REFERENCE:	Nova Bus Manuals
SECTION:	12: Interior Furnishing
RS N°:	MQR 7621-1007
EFFECTIVE IN PROD.:	N/A

SUBJECT:	Articulation stanchion
JUSTIFICATION:	New improved stanchion is now available for installation in the articulation section of the vehicle.

Figure 3 - Removal of Stanchion

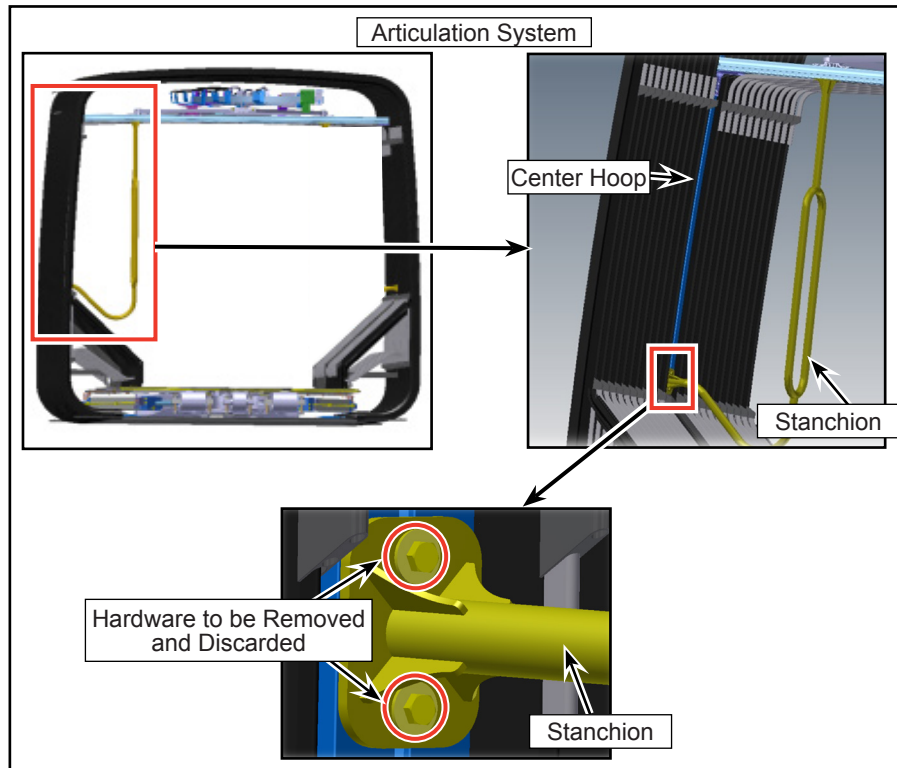
- 1.4. Remove the existing stanchion fixed to the center hoop of the articulation. Discard the stanchion, bolts and washers (see Figure 3).

Figure 4 - Typical View of Tenon Block

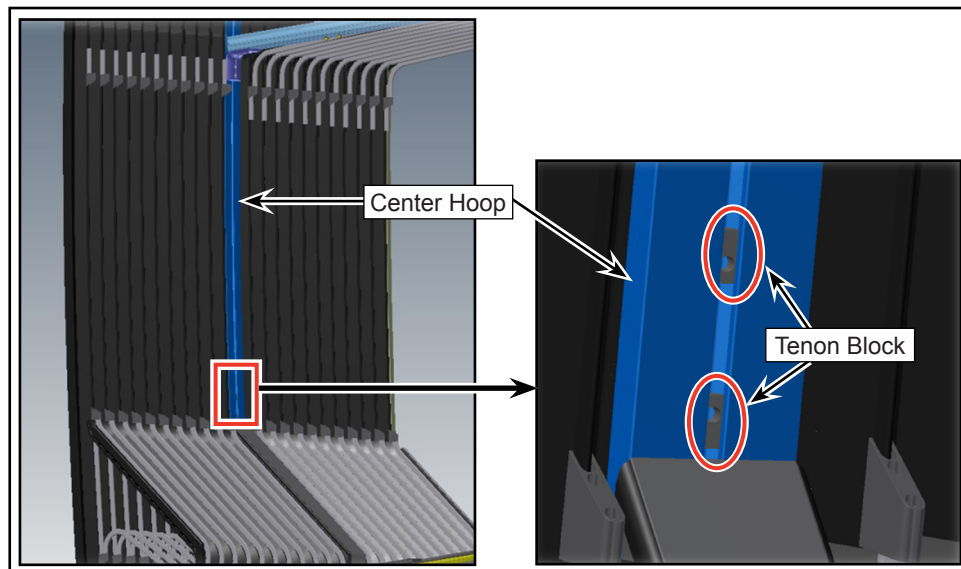
- 1.5. Retain the tenon blocks at the same location (inside the center hoop aluminium profile) as shown (see Figure 4).

Figure 5 - Installation of Tenon Block

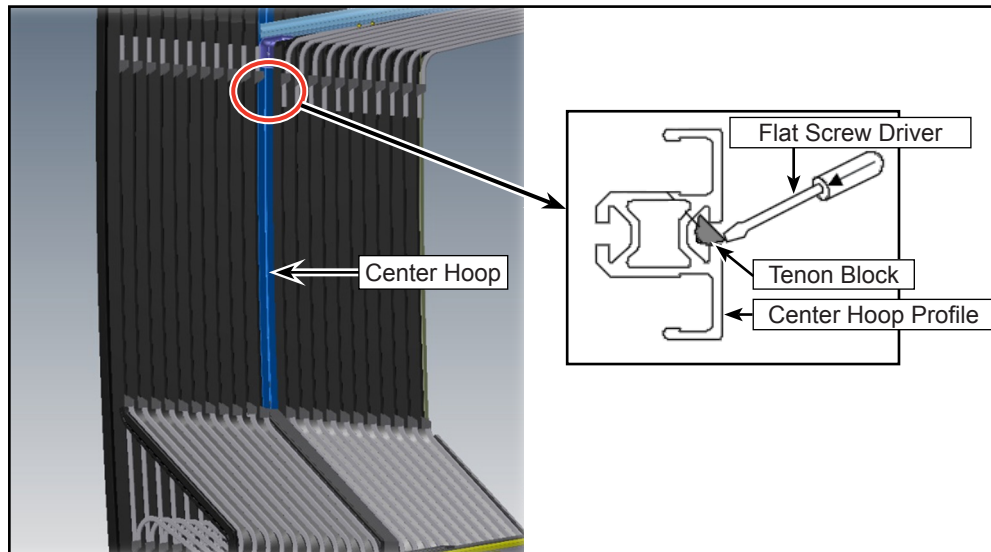
- 1.6. Install the new tenon block into the center hoop profile (right below the horizontal guiding profile) with a flat screw driver as shown (see Figure 5).

Figure 6 - Installation of New Stanchion

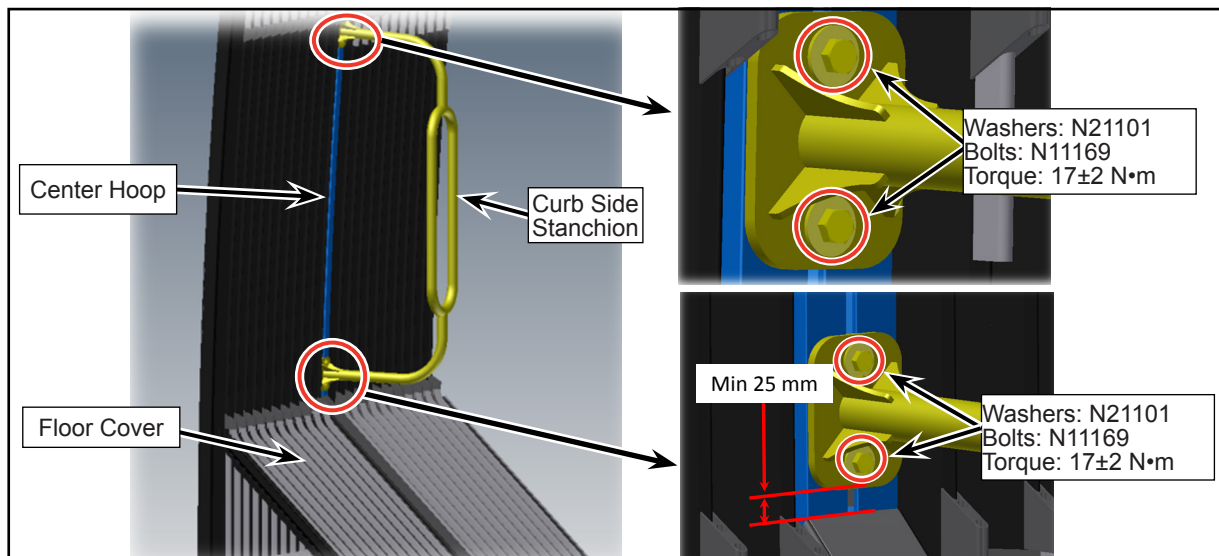
- 1.7. Install the new stanchion on to the tenon block present inside the center hoop profile with the hardware provided. Ensure that the stanchion provided is installed on curb side of the bus (see Figure 6).
- 1.8. Ensure that enough gap (Min. 25 mm) is left between the lower edge of the stanchion and the floor cover profile as shown (see Figure 6).
- 1.9. Apply blue thread locker and torque the bolts as specified (see Figure 6).

Figure 7 - Typical View of Stanchion Orientation

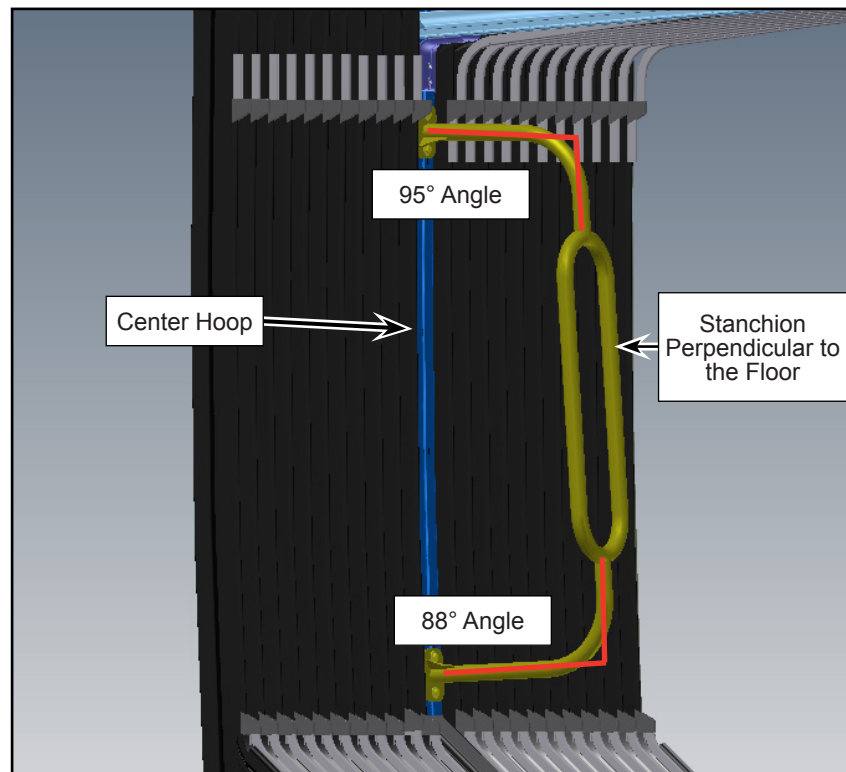
- 1.10. Ensure that the curb side stanchion is vertical (perpendicular to the floor) (see Figure 7).
